ADDENDUM
AD #3

Project **West Point Dairy - Hyrum - Storage Warehouse**
Project No. **250429500**
Location **Hyrum, Utah**
Date **August 3, 2026**

STORAGE WAREHOUSE EXPANSION FOR:

WEST POINT DAIRY PRODUCTS

SNOW DRIFT LOAD PLAN - AREA 'A'

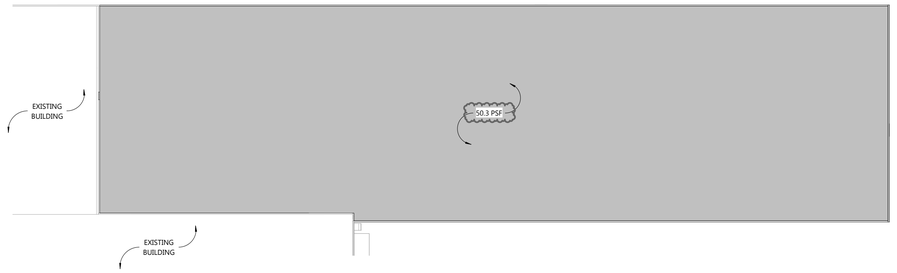
Updated Sheet Index for removed S2.3 sheet.
S0.2	Updated Structural Design Criteria to updated IBC 2024 code.
	Updated Components and Cladding Wind Zones graphic to ASCE 7-22 diagram.
	Updated Snow Drift Load Plan - Area 'A' for updated snow load.
S0.3	Updated Snow Drift Load Plan - Area 'B' for updated snow load.
S1.1A	Removed Grade Beam ties [No longer required for soil class update to Class D from soil mixing] and associated S2.3 sections and F3 Keynote.
	Updated Pier sizes and names for anticipated pier sizes.
	Added Preliminary Design note for PEMB foundations.
	Updated Foundation Keynotes schedule for removed F3 Keynote.

SILO PRELIMINARY DESIGN

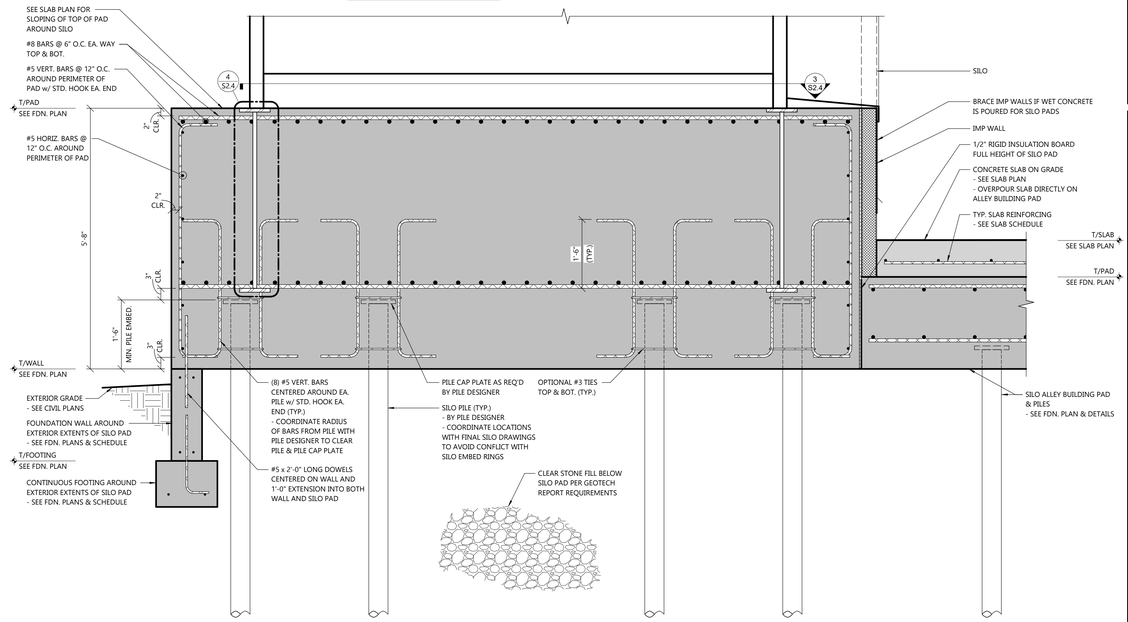
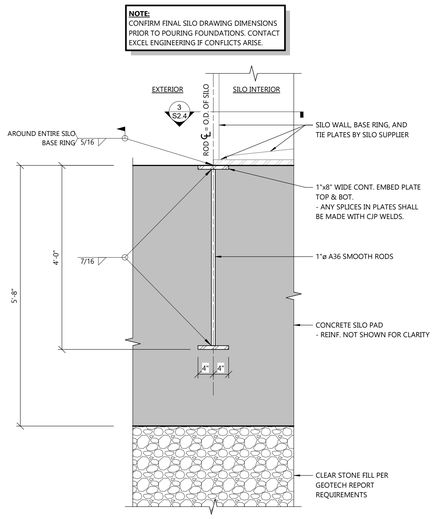
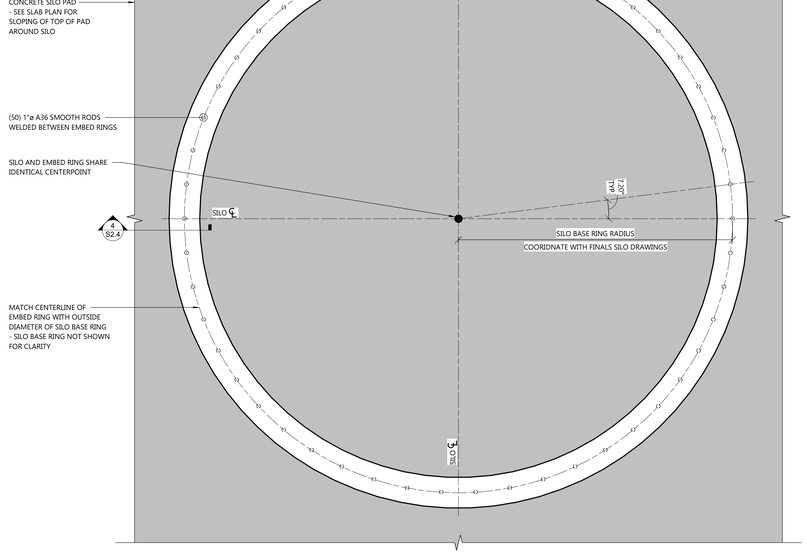
S1.1B	Added Preliminary Design for silo foundations.
S2.0	Updated Pier Schedule to show anticipated piers with preliminary design note.
	Added New Fnd. to Exist. Fnd. Dowel Detail.
	Renamed Typical Pier Details to specify rectangular and round.
S2.1	Updated PEMB column bases to show anticipated designs with preliminary design note.
	Added Tension and Shear Embed Plates.
S2.2	Removed preliminary design from SG-8 in Concrete Slab on Grade Schedule.
S2.3	Removed foundation sections associated with grade beams [1/S2.3, 2/S2.3, 3/S2.3, and 4/S2.3].
S2.4	Added Preliminary Design for silo foundations.
S3.0	Removed prliminary design from DK-S1 in Steel Deck Schedule.
H0.1	Updated design criteria and specs to IMC & IECC 2024.
H4.0	Updated Ductwork schedule note to reference IECC 2024.

- SILO PAD SIZE, SILO PAD REINFORCEMENT, PILE LAYOUT, AND PILE CAPACITY ARE BASED UPON ASSUMED GEOTECHNICAL RECOMMENDATIONS. DO NOT PRODUCE SHOP DRAWINGS, FABRICATE REBAR, DESIGN PILES, OR FORM FOUNDATIONS USING THE DESIGN SHOWN ON THIS SHEET.
- ENGINEER WILL RELEASE A CONSTRUCTION BULLETIN WITH UPDATES AFTER COORDINATION WITH GEOTECHNICAL ENGINEER HAS BEEN COMPLETED. THIS NOTE WILL BE REMOVED WHEN IT IS ACCEPTABLE TO BEGIN TO PRODUCE SHOPS DRAWINGS FOR THE FOUNDATION REBAR AND PILES SHOWN ON THIS SHEET.
- ANY SHOP DRAWINGS PRODUCED PRIOR TO ENGINEER'S RELEASE OF FINAL INFORMATION WILL BE RETURNED REJECTED WITHOUT REVIEW COMMENTS.
